Metro Outer Development Assessment Panel Agenda

Part B – Item 3.1 – Lot 1 (14) Lancaster Street, SPEARWOOD – Proposed 4 Grouped Dwellings

Form 1 – Responsible Authority Report
(Regulation 12)

Figure 2: Topography of 14 (Lot 1) Lancaster Street, SPEARWOOD.

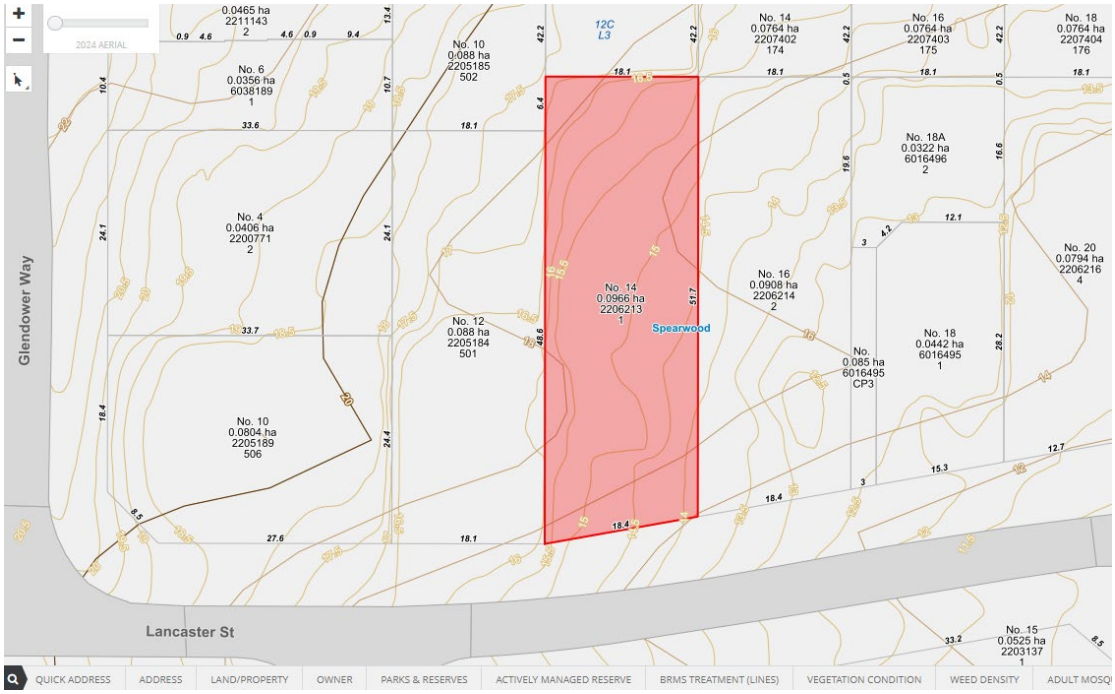
The subject lot is challenged by its topography, in which, its lowest point is on the south-east rising to its highest point on its north-west. The difference in levels for this lot from its south to north is ranging between 2-3m. To achieve an acceptable level for the lots whilst respecting the topography and seeking to comply with the requirements of Part C of the *R-Codes*, poses a challenge for this proposal. Figure 2 below provides an understanding for the topography of this lot.
